## Liquid Mixing Manifold (LXM) Visual Position Indicator Issue

### Issue

The Visual Position Indicator (VPI) on some LXM actuators may remain in the “Open” position when the actuator returns to the “Closed” position.

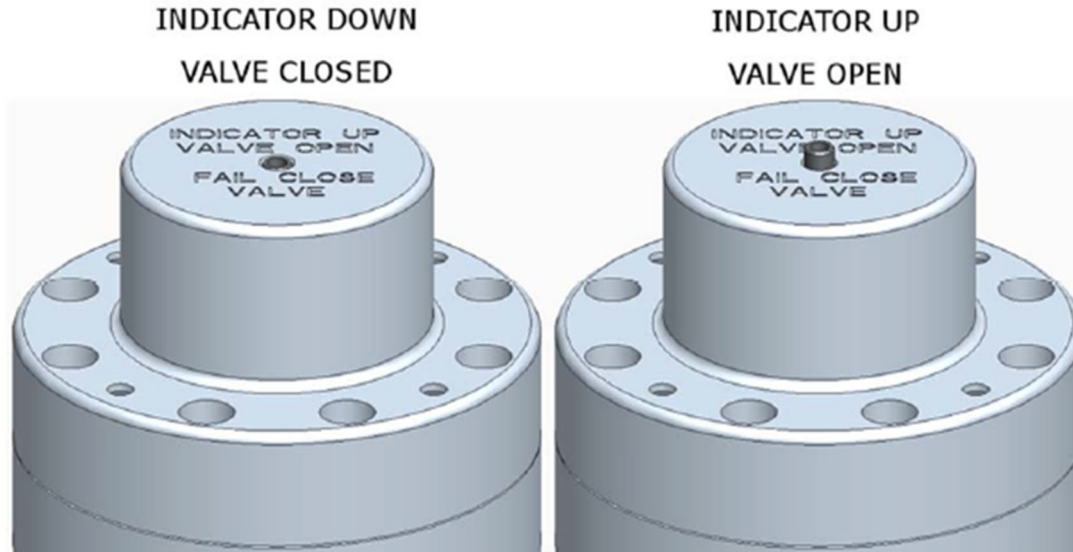
The VPI may remain in the Open position if the VPI rod disengages from the actuator piston due to low retention force of the rod and high friction between the rod and the environmental seal located in the actuator cover.

**Permanent Corrective Action:** A design change was implemented to prevent the issue by increasing the retention force between the VPI rod and the actuator piston. Lubrication will also be added to minimize the friction between the VPI rod and the environmental seal.

### Recommended Preventative Action:

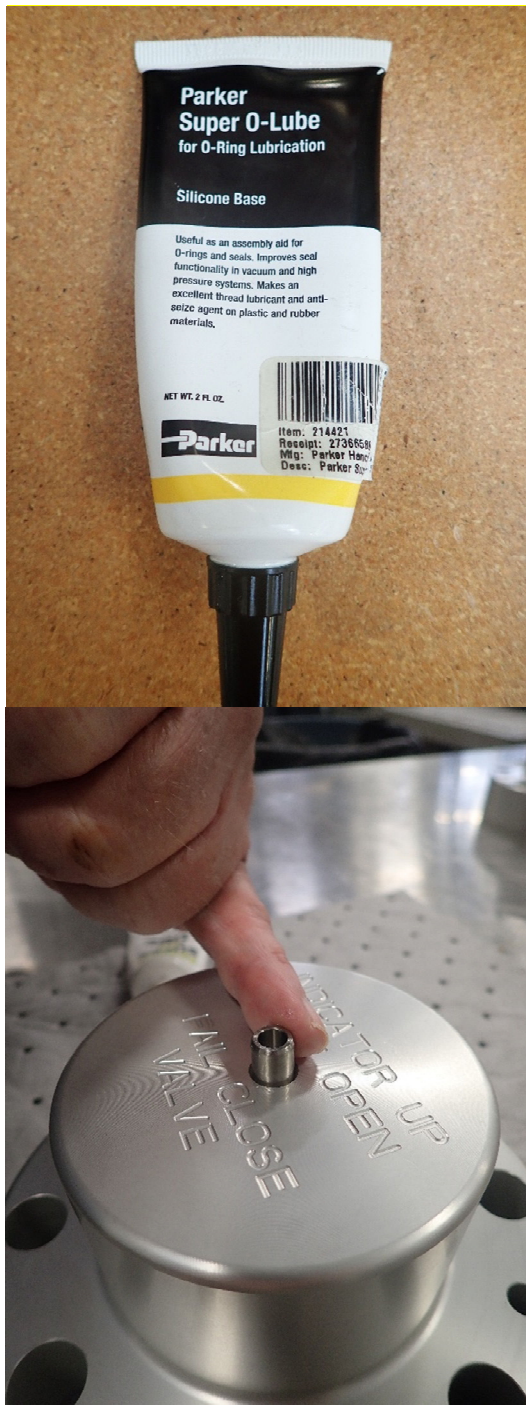
The recommended Preventive Action is to lubricate the VPI. The lubrication process may be completed with the LXM either mounted on the engine or on a work bench.

- 1 Obtain a silicone-based lubricant such as Parker Super O-lube (PN 2001-3014, 3016) or equivalent. Only these types of lubricant should be used to meet the high temperature requirements of the LXM. Woodward can provide the required lubricant if necessary.
- 2 Pneumatically actuate each LXM actuator to the Open position.
- 3 While in the Open position lubricate the exposed surface of the VPI rod and at the base of the rod, where it enters the cover. See photos below for lubrication locations  
Verify the VPI functions properly by closing and then cycling each actuator 3 times. Reference Woodward product manual B35113, page 7, figure 1-3, and page 22 "Routine Inspections"

Apply Parker Super O-lube or equivalent silicone-based lubricant to the exposed surface of the VPI rod and to where the rod enters the cover. Spread the lubricant across the rod surface with a finger leaving a thin film. Wipe off excess lubricant from the cover surface.
